**Project Address: 808-836 Courtland Ave E**  
**Application Type: Official Plan Amendment Application OPA24/011/C/AP**  
**Zoning By-law Amendment Application ZBA24/023/C/AP**

**Date:** December 2, 2024  
**To:** Andrew Pinnell  
**From:** Jason Brûlé  
**Subject:** Zoning By-law Amendment and Official Plan Amendment Application  
808 Courtland GP Inc.  
808-836 Courtland Ave E, Kitchener  
ZBA 24/023/C/AP  
OPA 24/011/C/AP

**Re: Regional Addendum Comments  
Official Plan Amendment OPA 24/011 and Zoning By-law  
Amendment ZBA 24/023  
808-836 Courtland Avenue East  
Zehr Group (c/o Kevin Muir) on behalf of 808 Courtland  
GP Inc.  
City of Kitchener**

Re: Road/Rail Traffic and Stationary Noise Impact Study  
Peer Review  
Proposed Residential Development  
808 to 836 Courtland Avenue East  
City of Kitchener  
Our File: 24-184

**FIGURE 1**

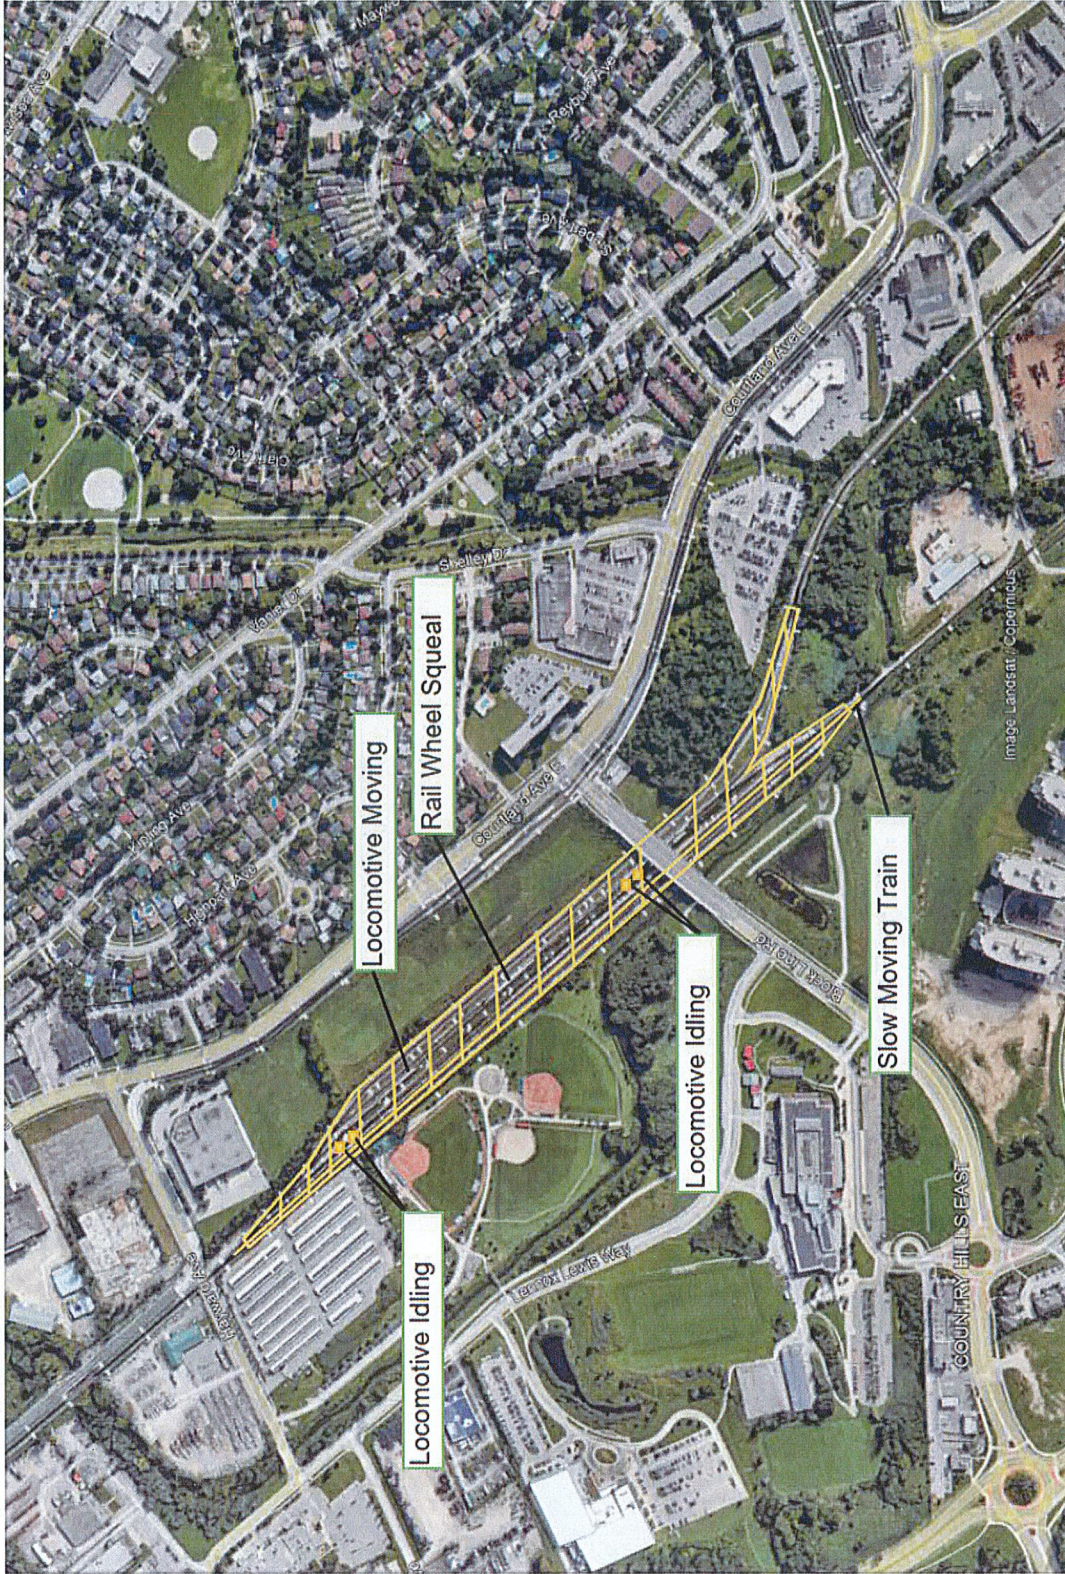
To assist in updating the noise study, included in Appendix A is a plan showing the locations of noise sources within the rail yard as well as tables providing the sound power information to be used in the analysis. Please note that the information regarding the rail operations is to be used solely for this project as CN may alter operations within the rail yard as needed.
